**Department of Planning and Environment**
Issued under the Environmental Planning and Assessment Act 1979
Approved Section 4.55 (1A) Modification Application
No: SSD 10437 MOD 1 Granted on 16 August 2022
Signed: AW Sheet No: 1 of 21

Project
WATERLOO METRO QUARTER DEVELOPMENT

Sheet title
General Arrangement Plan
Ground Floor Plan

Elevation - North

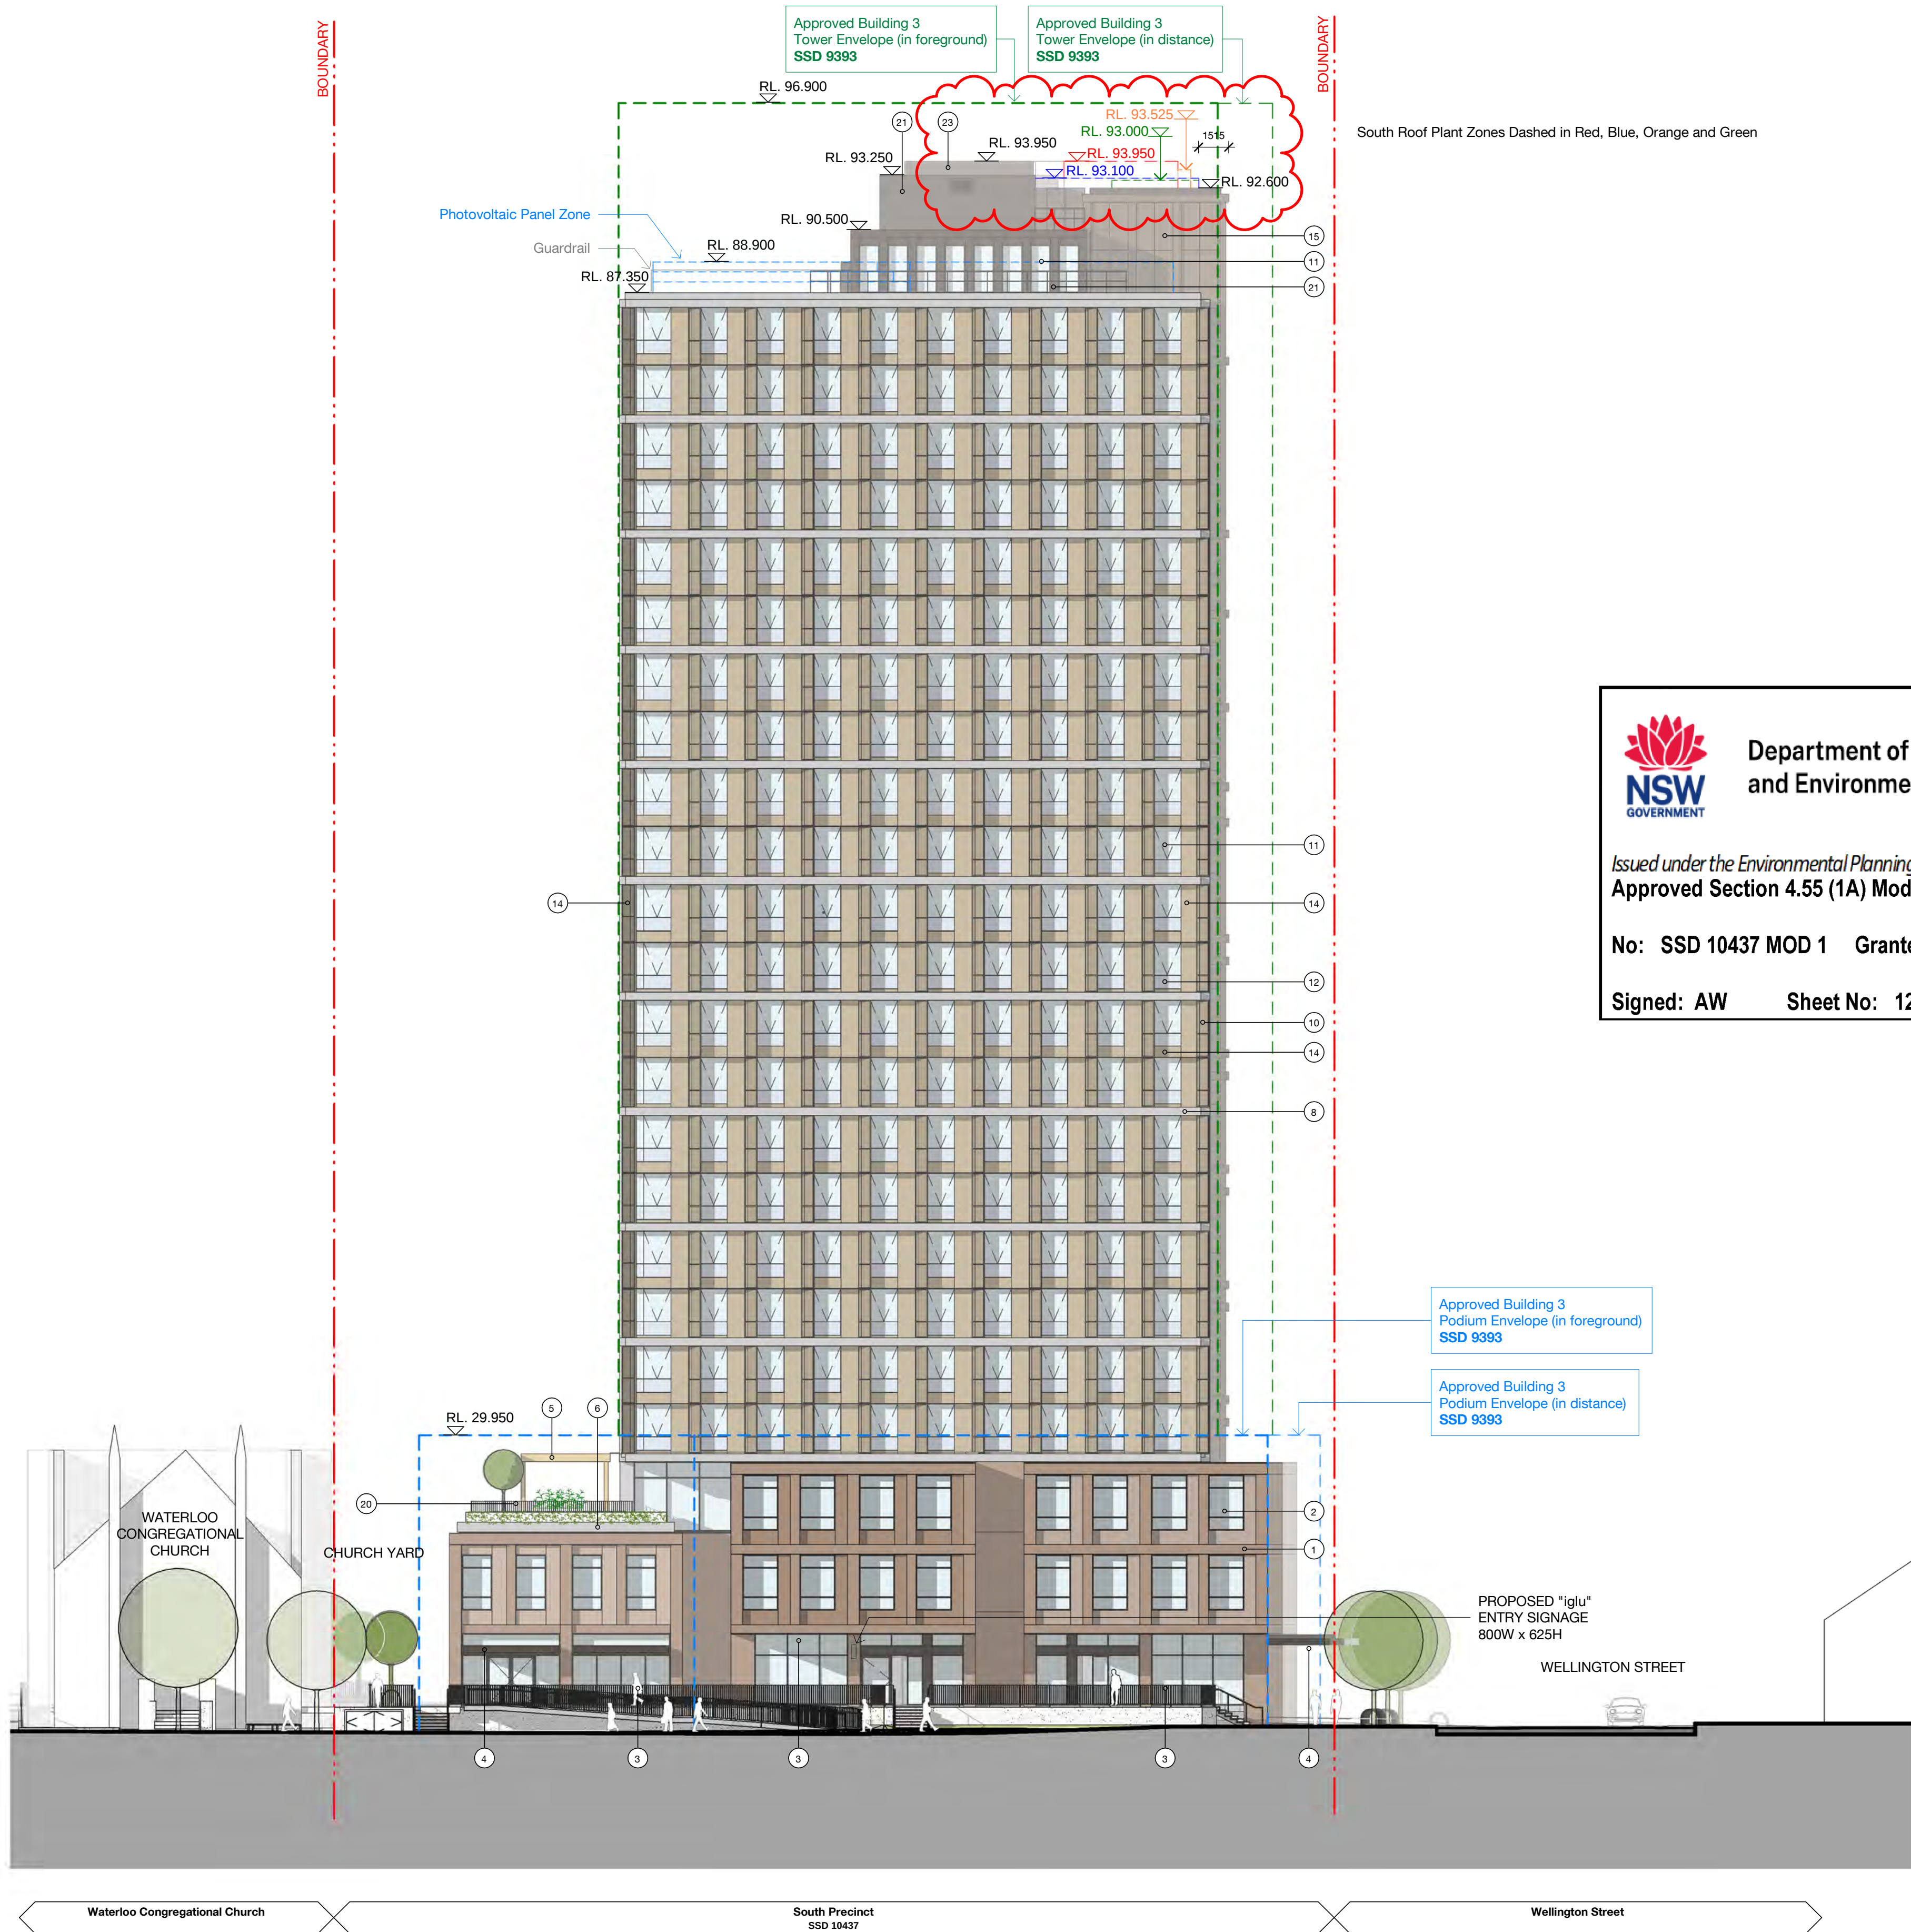
- Addition of louvres to the ground level and level 2

Elevation - West

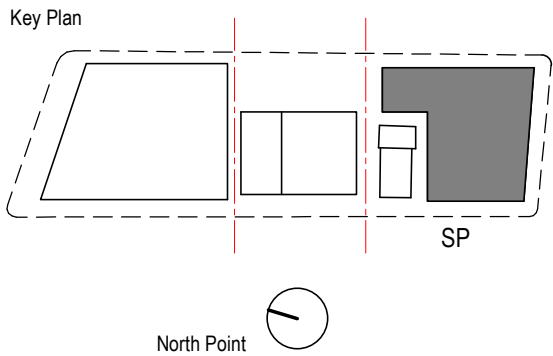
- Roof plant zone
- Addition of louvre to level 24 lift core
